DOCKETS 50-266 AND 50-301
SUPPLEMENT TO TECHNICAL SPECIFICATIONS
CHANGE REQUESTS 188 AND 189
POINT BEACH NUCLEAR PLANT, UNITS 1 AND 2

**RESPONSE TO REQUEST FOR ADDITIONAL INFORMATION
TECHNICAL SPECIFICATIONS CHANGE REQUESTS 188 AND 189**

FIGURE 1-2, CR-HVAC SYSTEM MODES
(MAJOR FLOWPATHS SHOWN DARKENED)

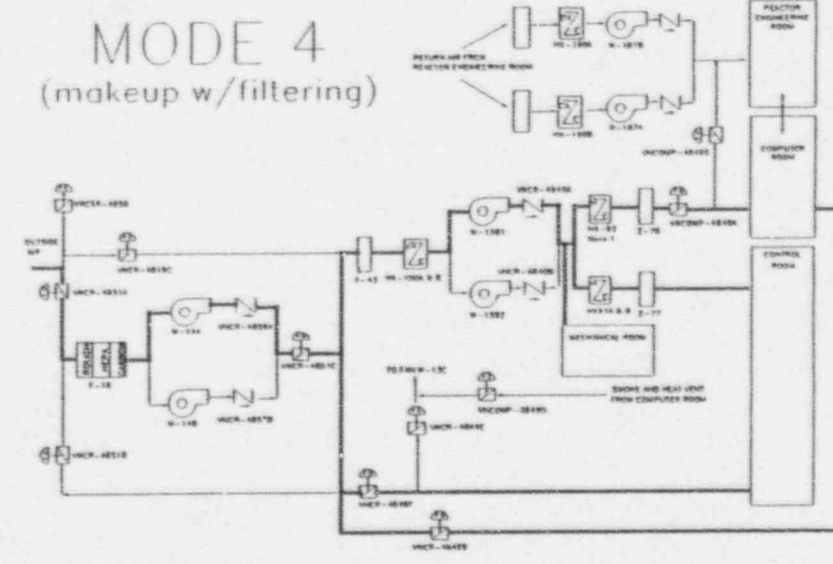
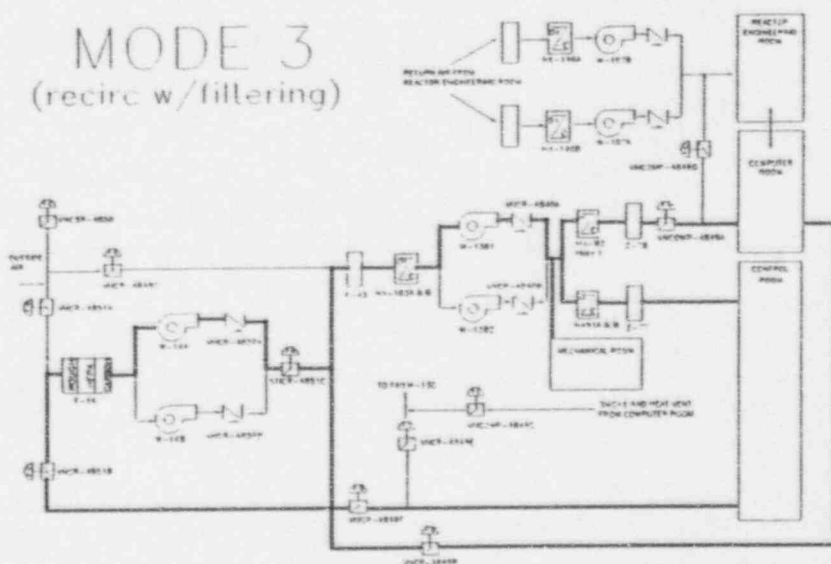
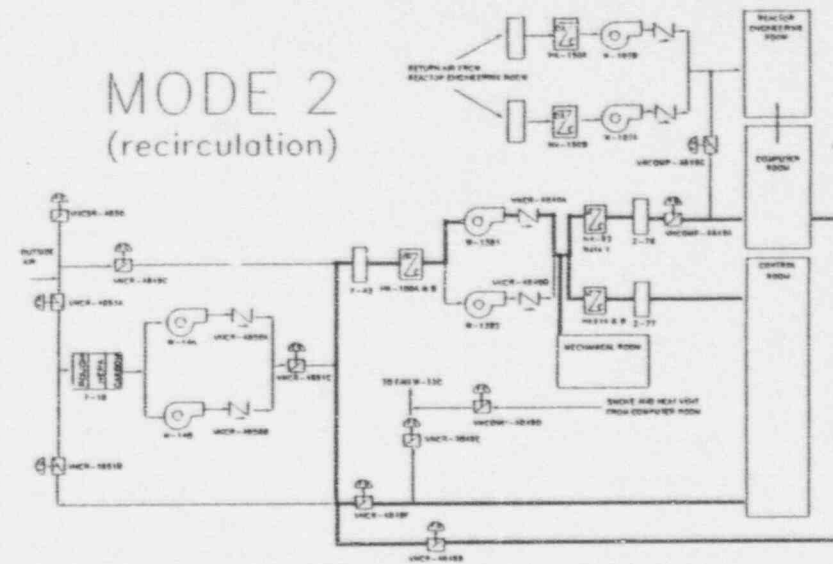
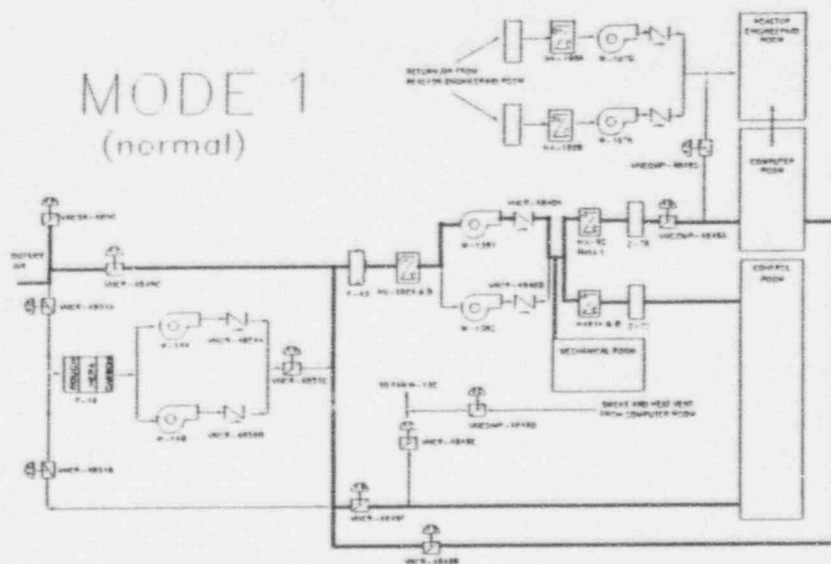
1. Describe the modes of operation of the control room heating, ventilation, and air conditioning (HVAC) system, including the following: control room habitable volume in cubic feet, range of assumed flow rates (recirculated flow, fresh air inlet flow, filtered air flow) used for dose calculations, assumptions of inleakage and outleakage, pressurization assumed in inches of water gauge and basis for assumption, descriptions of the filters used including assumed removal capabilities. Describe any additional protective measures included in calculation of control room dose.

Modes of operation of the control room HVAC system

Mode 1 is the normal control room HVAC operational mode. In this mode, 5% of the air flow is outside air and 95% is recirculated air. (Reference 1,2)

Mode 2 is initiated by a containment isolation signal or manually from the control room. In this mode, 100% of the air is recirculated. (Reference 1)

Mode 3 can only be initiated manually by operator action. This mode is similar to Mode 2 since 100% of the air is recirculated. However, in this mode, 25% of the recirculated air is filtered. (Reference 1,2)

Mode 4 is initiated by a control room radioactivity signal or manually from the control room. Mode 4 operation is 25% filtered outside air and 75% recirculated air and is considered a "positive pressure" mode for inleakage considerations. (Reference 1,2,9)

PBC-231
Plot Plan

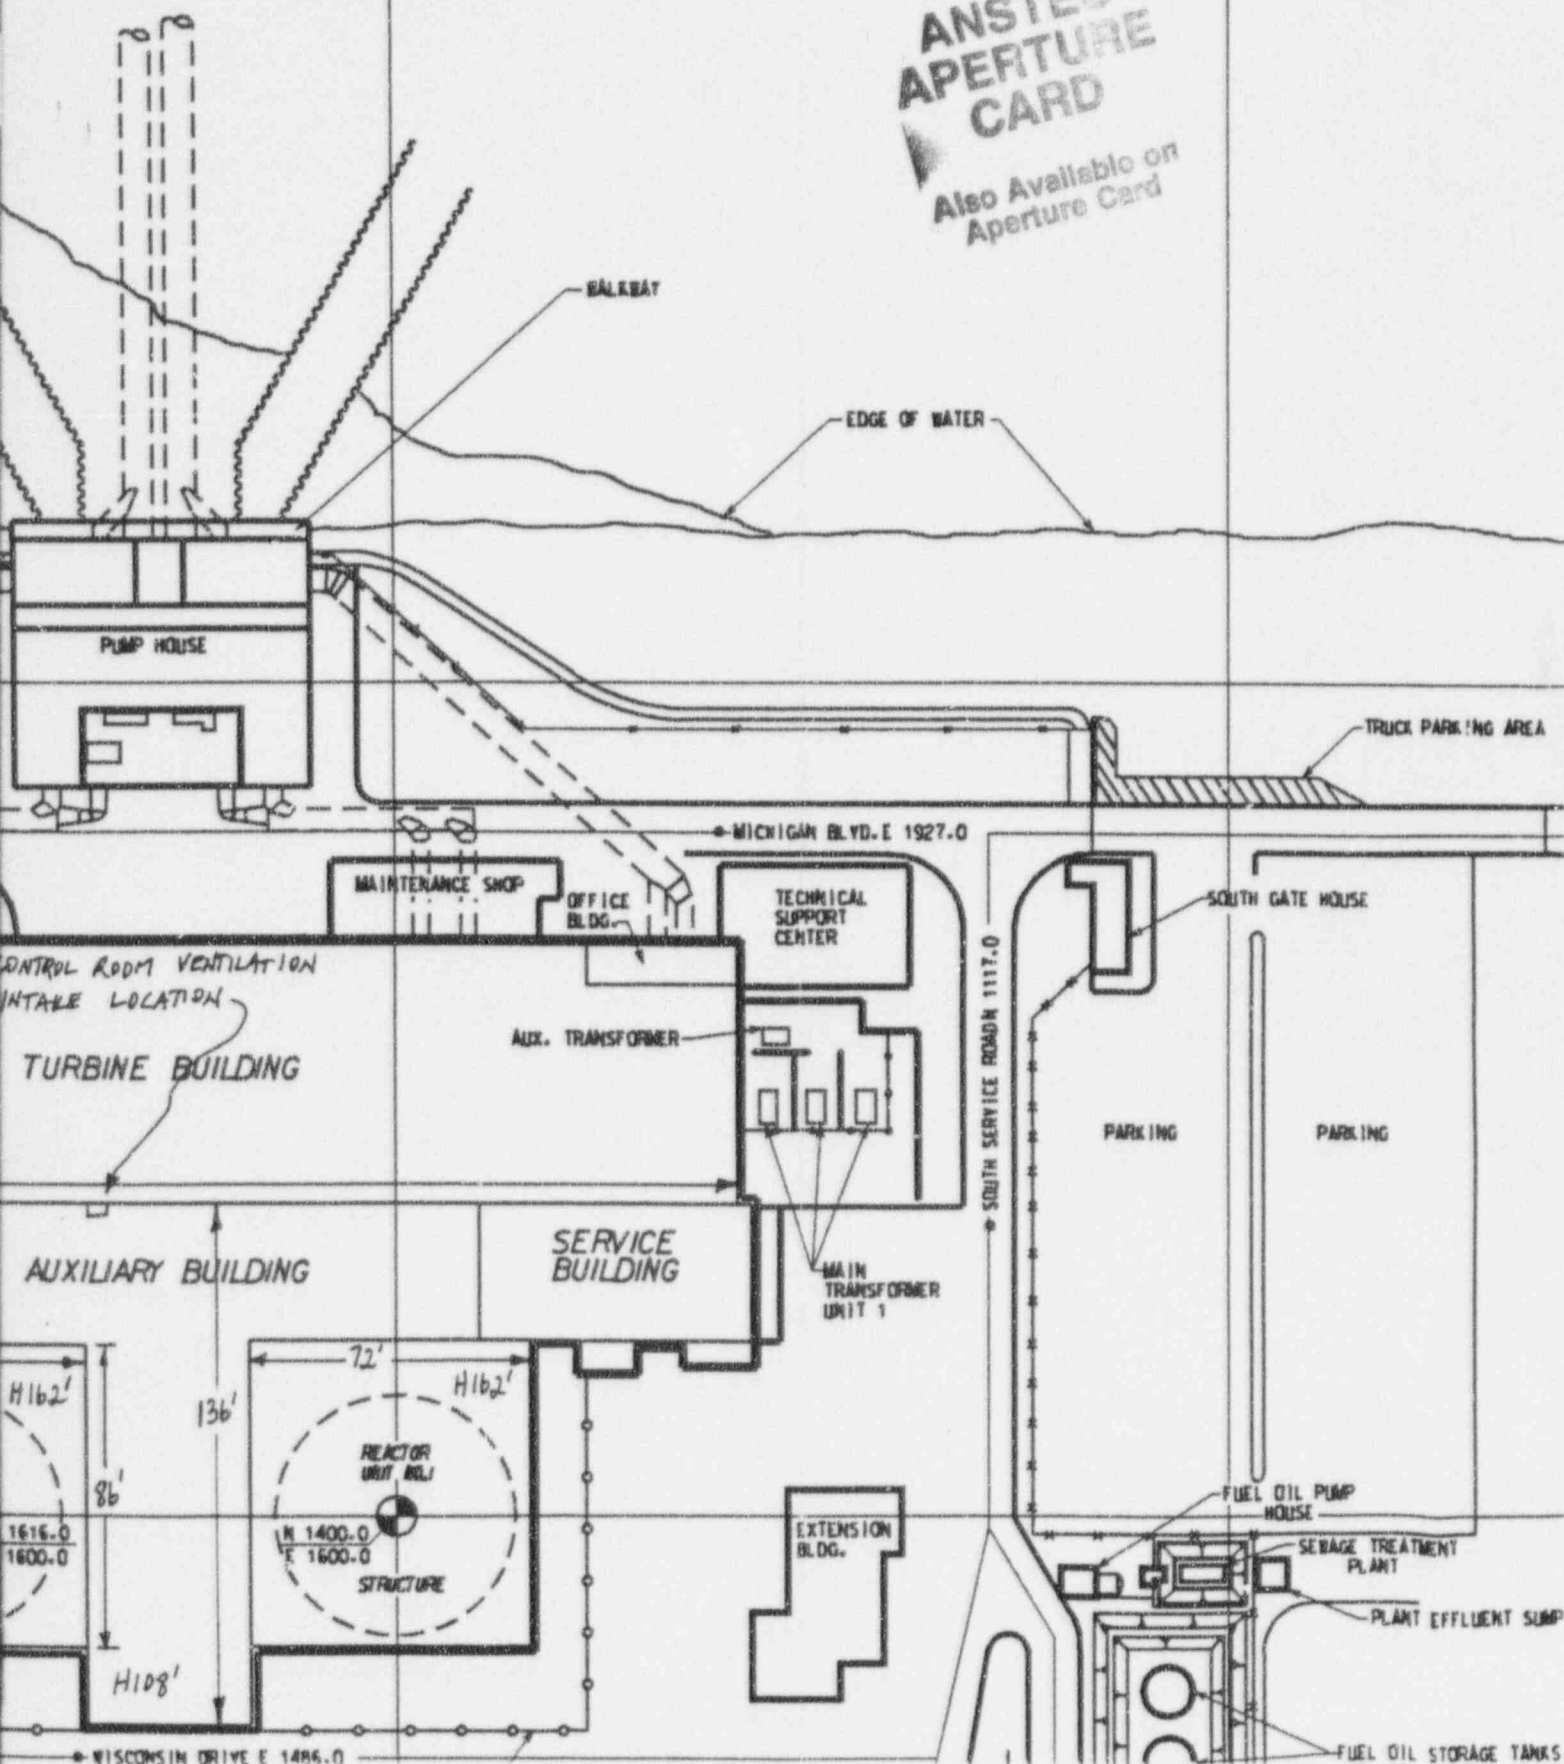
2b. Dimensions of buildings and other structures adjacent to or separating the release point and the intake/receptor

The dimensions of the buildings and structures adjacent to or separating the release point from the intake/receptor are shown on the attached drawing which is a modified version of reference 3. The elevation of the top of the structures are indicated on the drawing by capital H followed by the height in feet. (Example H162') Ground level near the plant is 26 feet.

The smallest plane cross-sectional area presented by the containment building is 1640 square meters. (Reference 1, p. 2.6-11)

The maximum adjacent building height either upwind or downwind from the release point is 41.3 m. (Reference 2)
